# SUNNINGDALE PARISH COUNCIL

**20/01676 - Pennington Church Road Sunningdale Ascot SL5 0NJ**

**New side boundary treatment and alterations to the existing side boundary fence;**

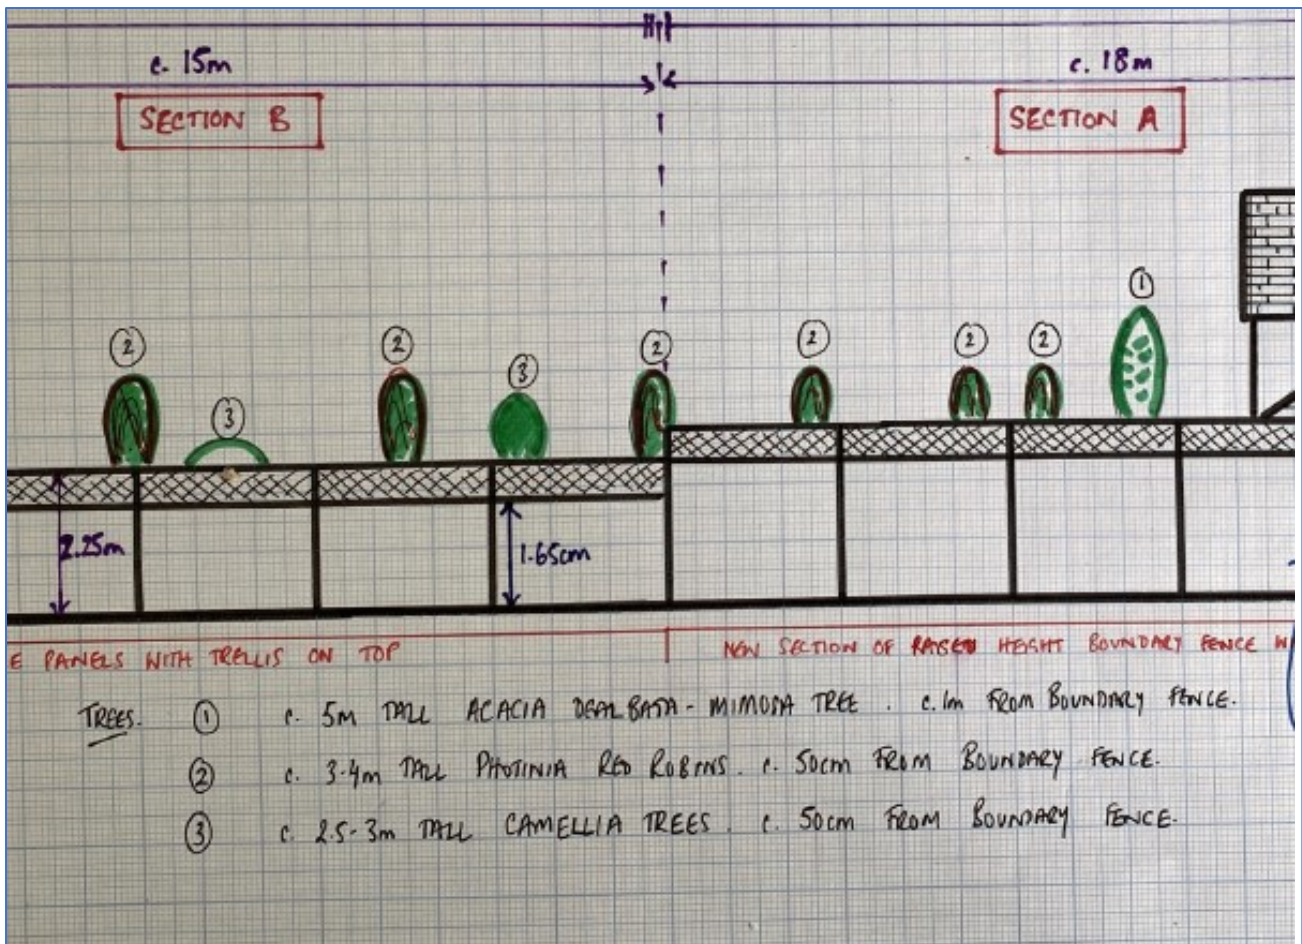
1. The Parish Council would request the Tree Team confirm that the proposed foundations for new sections of the fence, especially Section A, do not interfere with the RPA of the Yew tree in the adjoining Firs property.
2. Whilst there is no mention in the Design & Access statement about the impact on existing trees and neither is there an accompanying arboricultural report the plans do show 5 trees within 50cms and 1m of Section A which is a proposed new fence complete with new foundations.

There is a reference to this on the hand drawn plans shown below.

The remaining 4 trees within Section B would presumably not be affected as the intention is to just add a trellis on top of Section B fencing, rather than replace it.

We would request that the Tree Team also review any impact these foundations might have on these trees.
